**Re: Agnico Response to KIA Comments regarding Water License 2AM-DOH1335 – Conditions Applying to Construction and Operation – Construction of 2022 Interim Dike**

Agnico Eagle Mines Ltd. (Agnico) is providing this letter in response to comments received from Kitikmeot Inuit Association (KIA) on October 19<sup>th</sup>, 2022. Agnico's response is detailed below:

Fig 1. – Interim Dike FSL Graph (100m buffer actually reached at water El. ~34.4 masl)

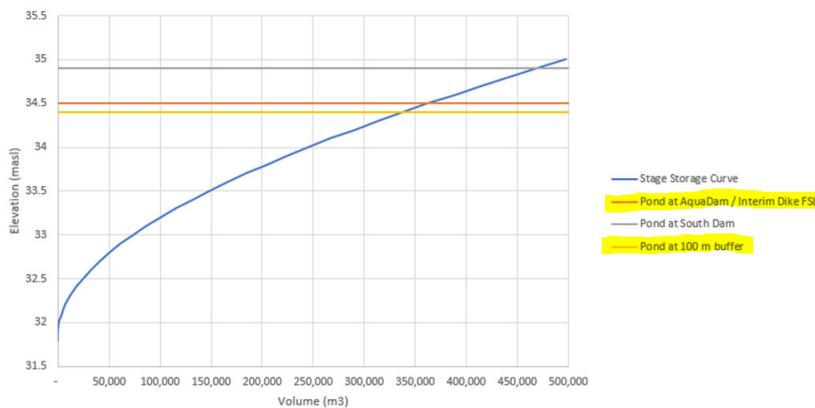
**Summary:** The maximum elevation of the water level upstream of the interim dike will be 34.5 m. This will submerge much of the existing tailings beach at the toe of the South Dam.

**Detailed Review Comment:** As documented in previous project documentation, there is a minimum beach length requirement upstream of the South Dam. It is unclear if the proposed maximum water level upstream of the interim dike will result in a beach length that still complies with the operational requirements.

**Recommendation/Request:** Can AEM comment on how the maximum water level of the pond

upstream of the interim dike will impact the beach length upstream of the South Dam and if this will comply with existing minimum beach length requirements for the TIA.

The maximum water elevation for the interim dike is controlled by an overflow channel with an inlet elevation of 34.5 masl. During the design process for the Interim Dike, the elevation for the channel inlet was selected such that the operation beach length requirement (100 m) is maintained at the South Dam (see figures below).
